Riverside Community Library - Facilities Permit Packet

Permit Application + Intake Cover | Rev 2 resubmittal 2026-06-11

PERMIT NO.	PARCEL	ZONING	OCCUPANCY	TYPE
PR-26-18422	073W22AB-04400	PS - Public Service	A-3 Library	II-B

Code Summary + Occupant Load / Egress Plan

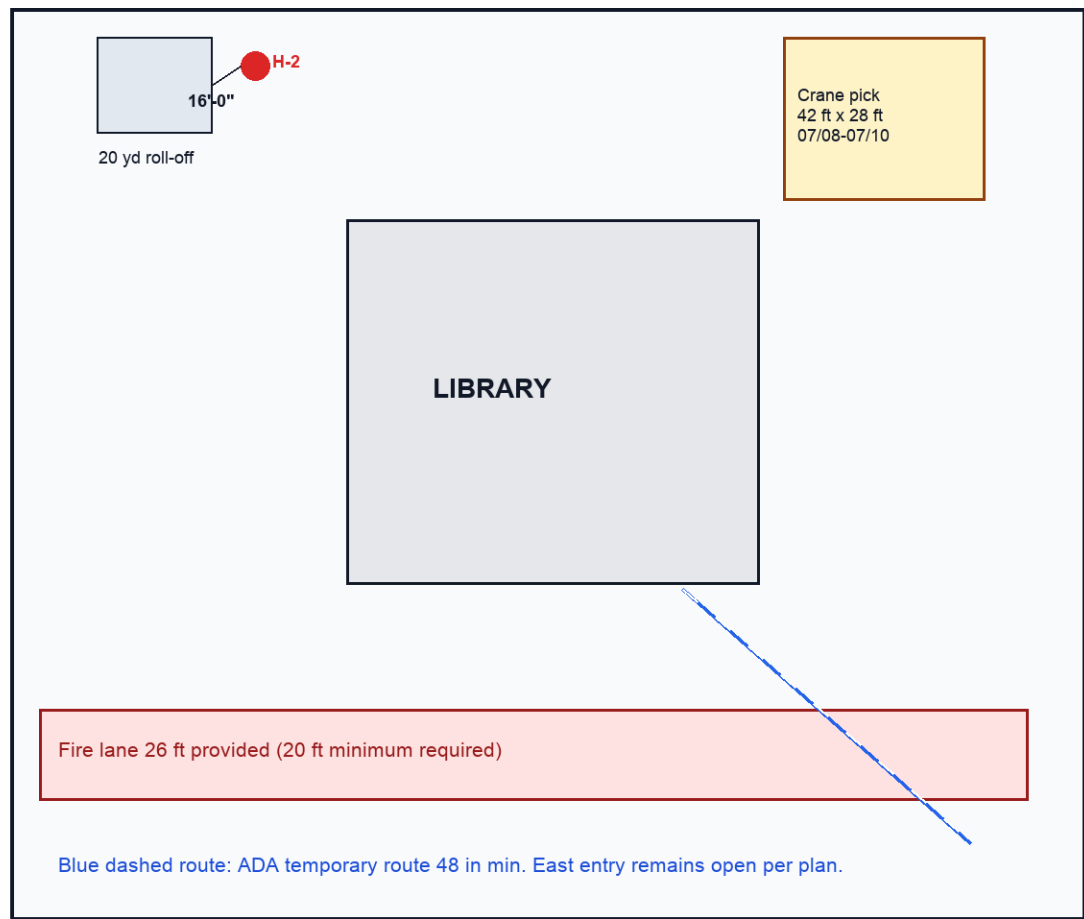
OL calc must include community room storage overflow. Cover note 'no change to occupant load' conflicts with calculated OL=113 and placard=92.

Accessibility note: Maintain 44 in min accessible route except at existing stacks pinch point noted.

Site Plan / Logistics / Fire Access

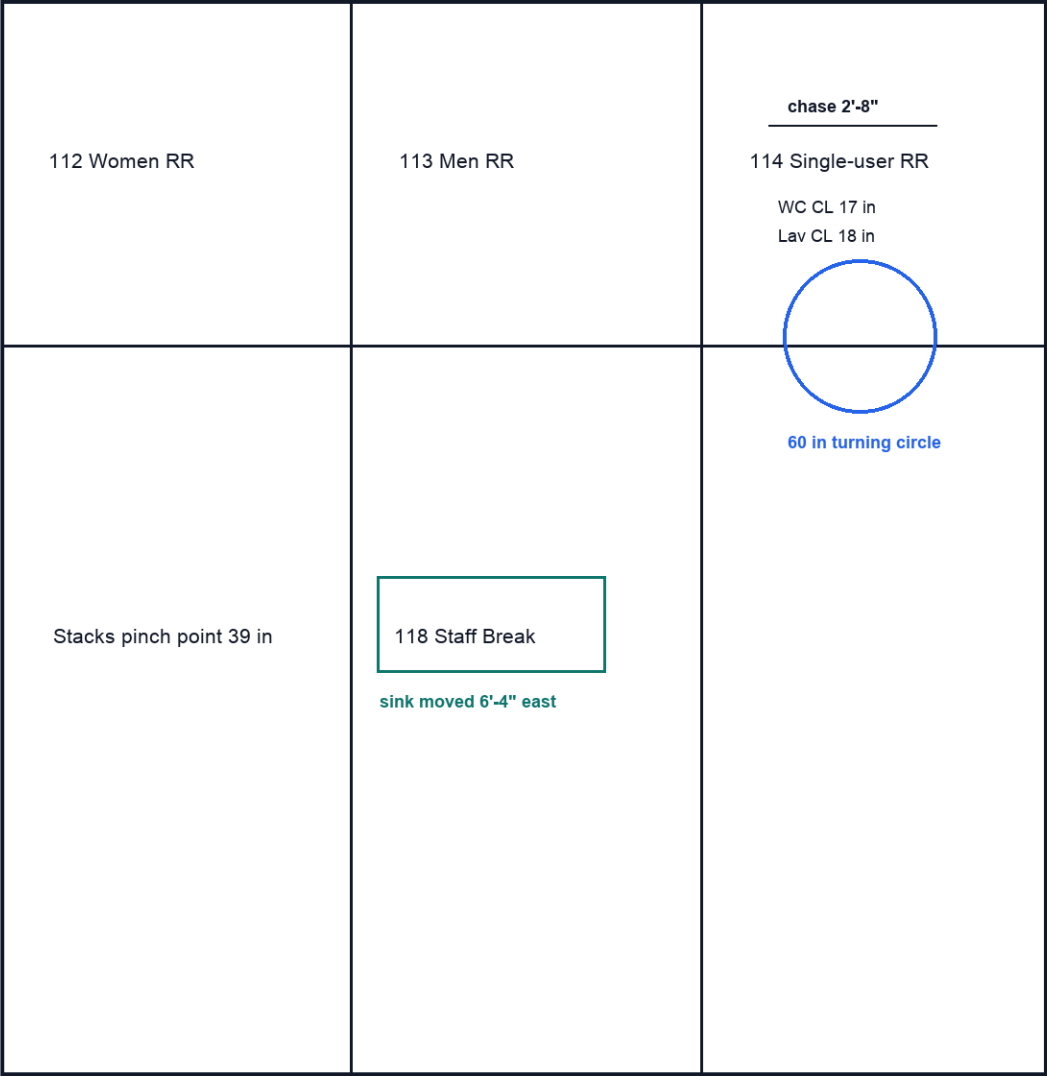
Fire access markup says do not stage within 20 ft of hydrant. Dimension string shows dumpster 16 ft from H-2.

- OBS-14: East entry route shown on logistics plan not maintained on 06/27; corrected route required before public opening.
- OBS-15: Dumpster within 20 ft hydrant clearance; move minimum 4 ft west.
- OBS-16: Room 114 chase revised per RFI-07; verify turning circle after lav shift.
- OBS-17: Curb C-3 field layout follows CO-02; confirm permit resubmittal reflects structural opening.

M1.3 / E1.2 Mechanical + Electrical Coordination Overlay

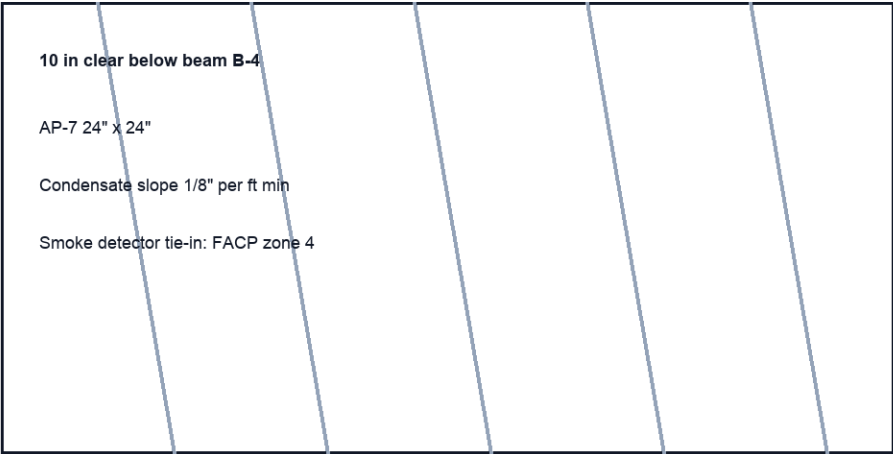
Mechanical C-3 opening: 54" x 78". Structural curb detail / CO-02 later requires 58" x 80".

This sheet lists 4 RTUs totaling 25.5 tons. Do not add ERV-1 to the original mechanical schedule; CO-02 adds it later.

Upsize RTU-3 from 10 tons to 12.5 tons. Add ERV-1 with 450 CFM outside air. Modify curb C-3 to 58" x 80". Add electrical breaker 3P-80A in panel MDP.
